April 24, 2020

Subject: Endorsement of NEI White Paper, "Changes to NEI 10-04 and NEI 13-10 Guidance for Identifying and Protecting Digital Assets Associated with the Balance of Plant," Dated April 2020

Project Number: 689

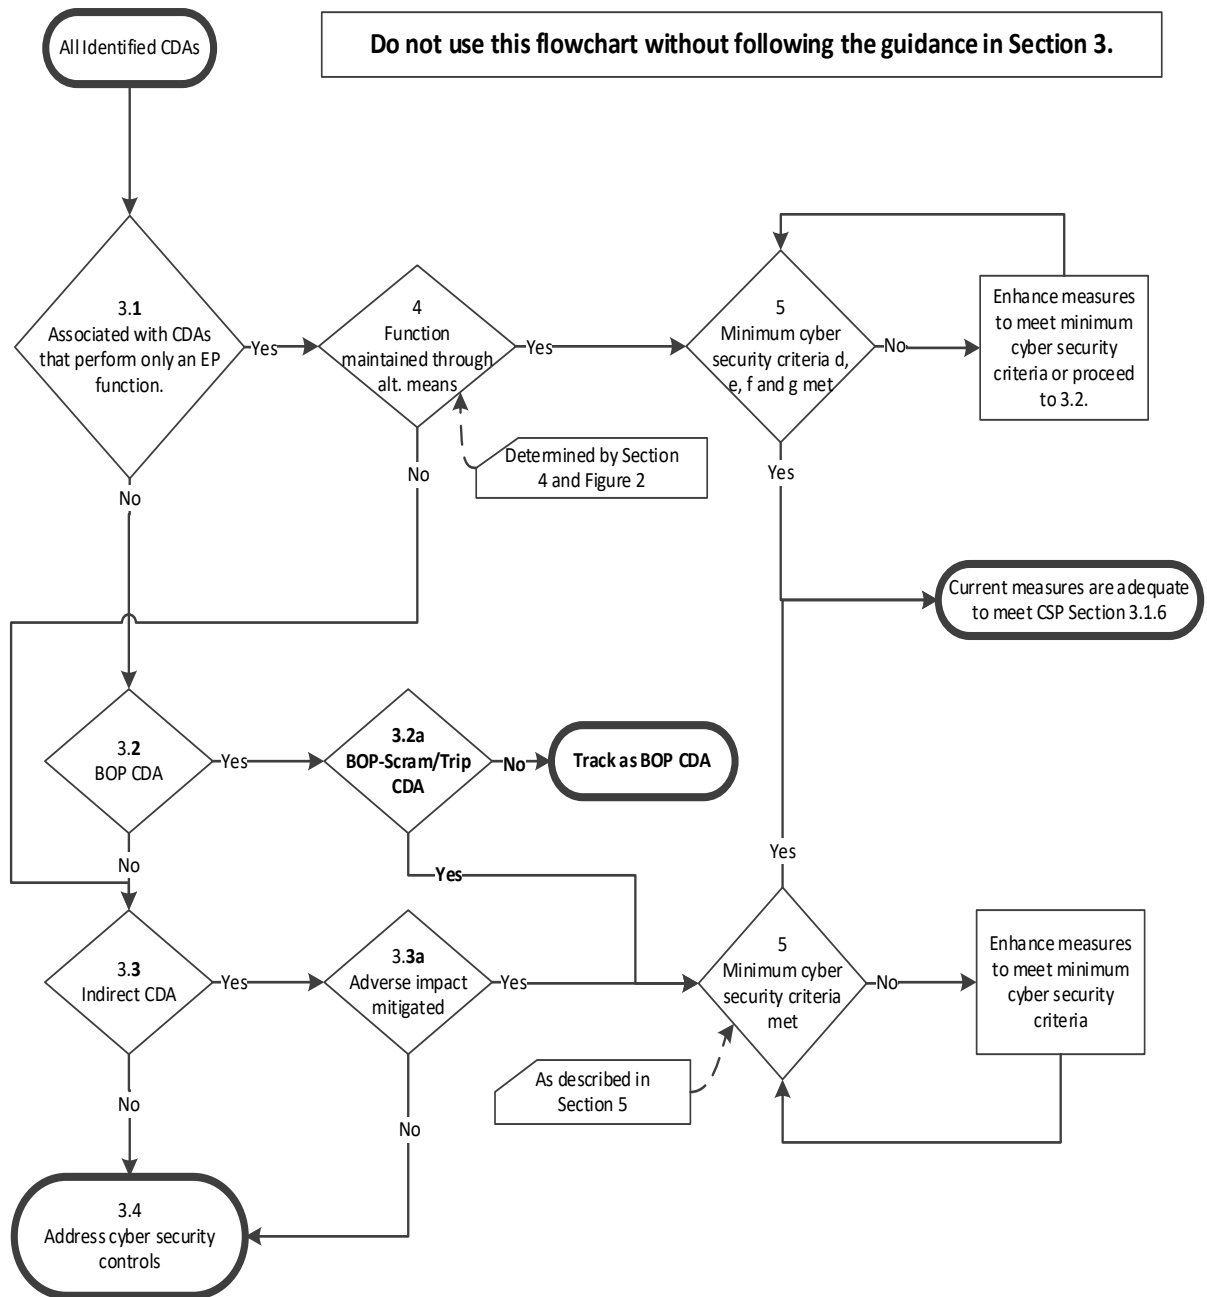
2.0 Figure 1, Box 3.2 Is the CDA a BOP CDA as described in Section 3.2? Document the CDA's function and the basis for YES or NO answer **as to why the CDA will cause generated megawatts to reduce to zero within 15 minutes or less.**

2.1 Figure 1, Box **3.2a Is the CDA a BOP-Scram/Trip CDA as described in Section 3.2? Document why the CDA meets the BOP-Scram/Trip Criteria in Section 3.2.**
